**Refuse Deflector Installation for
McNeilus or Agility 60 DGE CNG Roof
Mounted Systems**

Date: January 2, 2018
Bulletin Name: FEL-TSIB-052-A
Model: Contender FEL 87
Model Year: 2011 - 2017
Units Affected: McNeilus or Agility CNG
 Roof Mounted Systems

The following instructions are for installing a refuse deflector system on a 60 DGE McNeilus or Agility roof mounted Compressed Natural Gas (CNG) system to help prevent debris build-up between the back of the hopper deflector and the CNG cabinets.

Figure 1

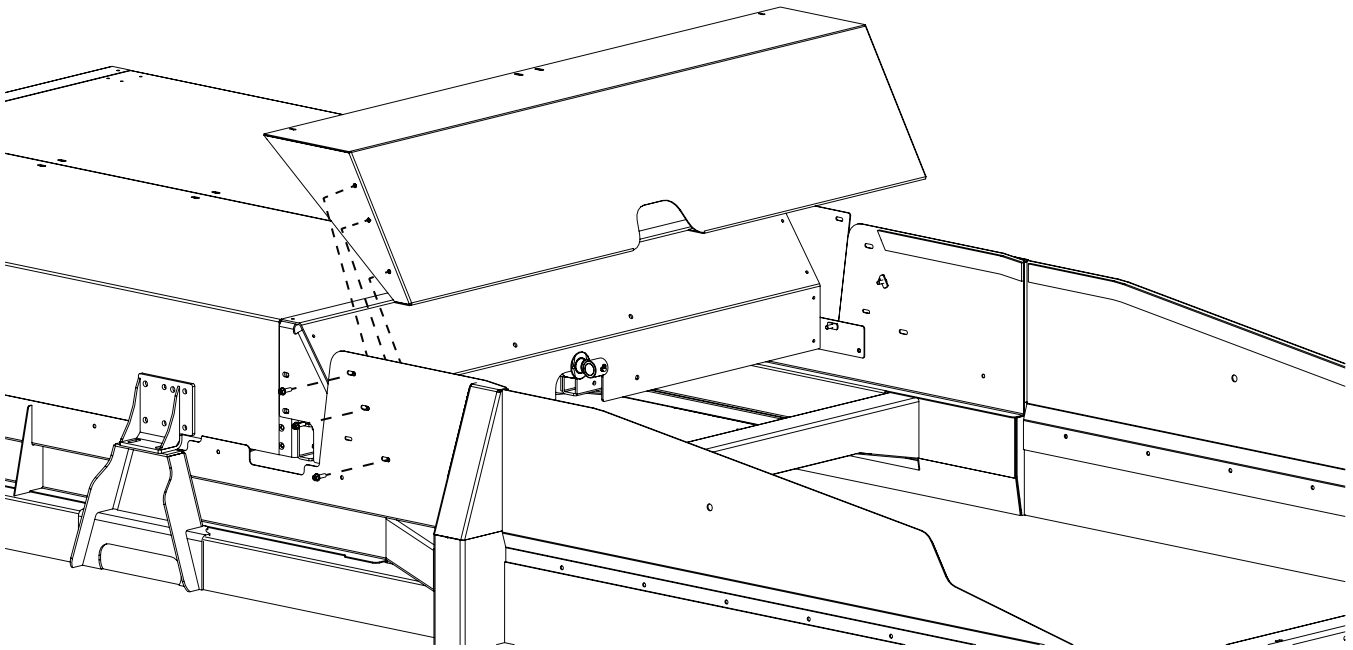
3. Remove and discard the existing refuse deflector and hardware (Figure 1).

Figure 2

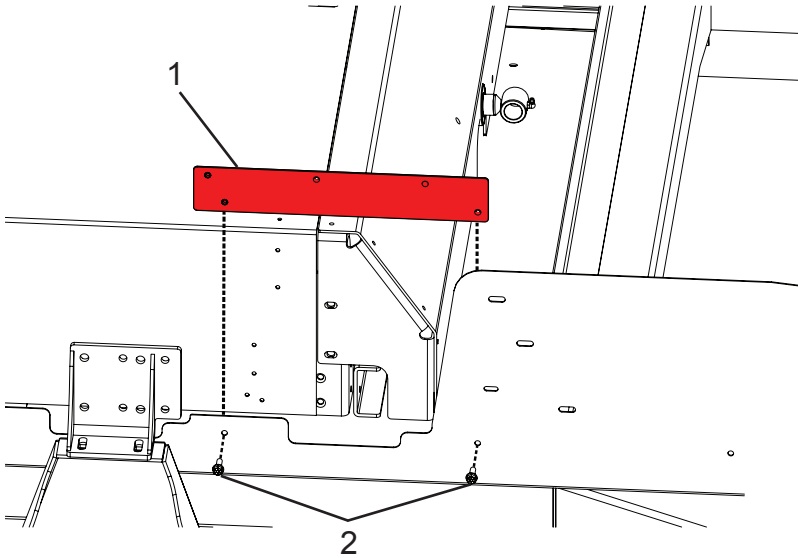
4. Starting on one side of the vehicle, install the rectangle cover piece ensuring the weld nuts are to the inside (Figure 2, Item 1). **NOTE:** Street side (PN 1572664) and curb side (PN 1572666) have different cover pieces.
5. Install (2) bolts (PN 1243637) to attach the cover piece to the vehicle windguard (Figure 2, Item 2).

6. Use a torque wrench to torque bolts to 33 ft.-lbs.
7. Repeat Steps 4 through 6 on the opposite side of the vehicle with the appropriate rectangle cover piece.

Figure 3

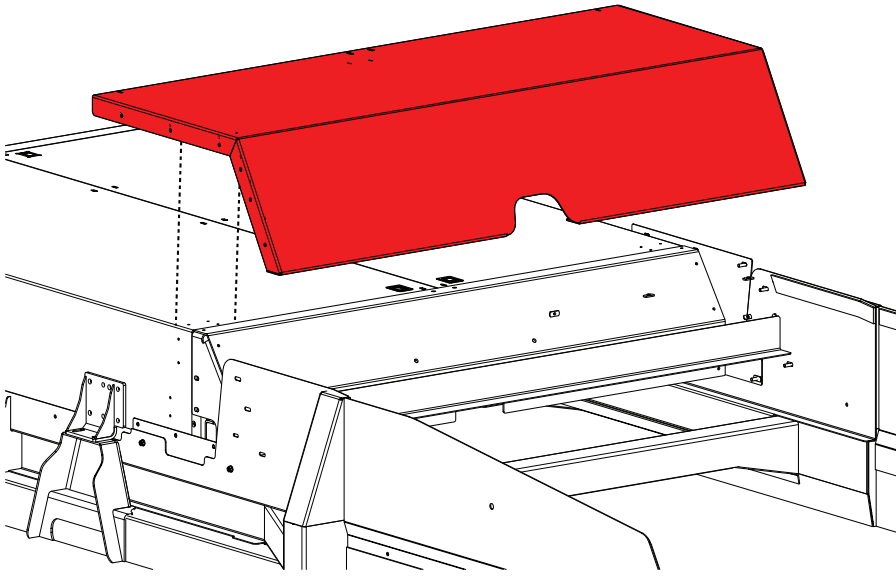
8. Attach the slings and overhead crane to the refuse deflector weldment cover piece (Figure 3) (PN 1572662).
9. Move the refuse deflector weldment cover piece into position at the roof mounted CNG system and line up the refuse deflector weldment cover piece so that you can install bolts in the three diagonal bolt slots on either side of the vehicle (Figure 3).

Figure 4

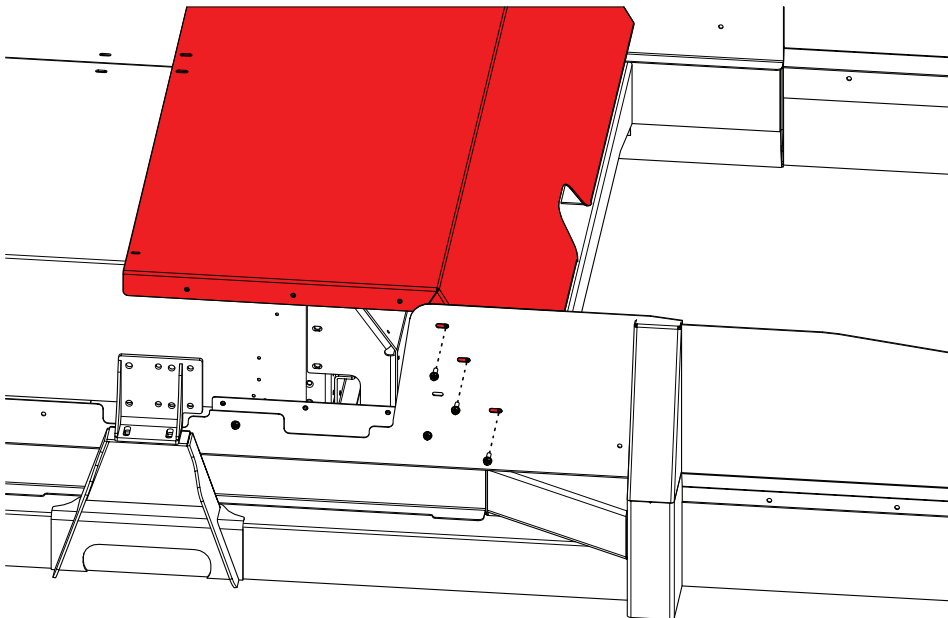
10. Install bolts in the three diagonal bolt slots on both sides to secure the refuse deflector weldment cover piece to the windguards (Figure 4).
11. Use a torque wrench to torque the bolts to 33 ft.-lbs.

Figure 5

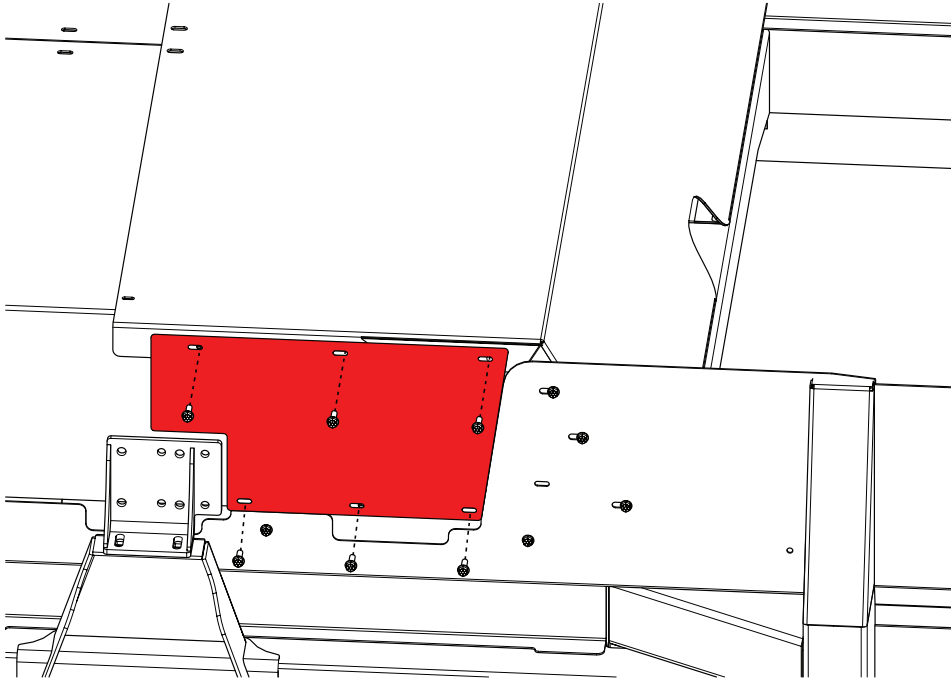
12. Starting on one side of the vehicle, install the large side cover piece (PN 1572667) so that it will attach to the refuse deflector weldment cover piece in three areas and to the rectangle cover pieces in three areas (Figure 5). **NOTE:** The side cover pieces go on the outside of the refuse deflector weldment cover and the rectangle cover pieces.
13. Use a torque wrench to torque the bolts to 33 ft.-lbs.

Figure 6

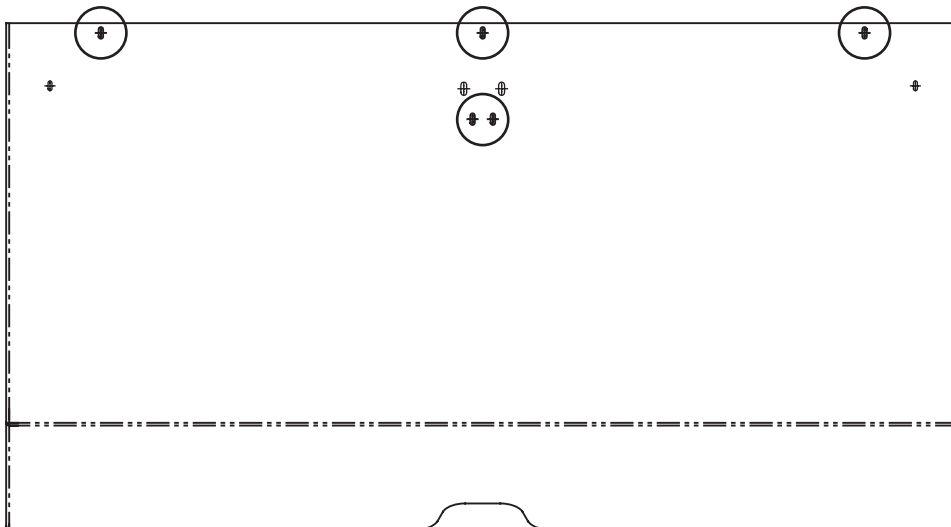
14. Repeat Steps 12 and 13 on the other side of the truck to install the second large side cover piece (PN 1572667).
15. Install the correct bolts across the top of weldment cover piece. The number of bolts and specific holes used will be based on if the CNG system is McNeilus or Agility. Figure 6 (McNeilus) and Figure 7 (Agility) detail the specific holes for each system.
 - McNeilus CNG system = Bolts PN 0120023, quantity 5
 - Agility CNG system = Bolts PN 1243637, quantity 4
16. Use a torque wrench to torque the McNeilus bolts to 9 ft.-lbs.
 - Use a torque wrench to torque the Agility bolts to 23 ft.-lbs.
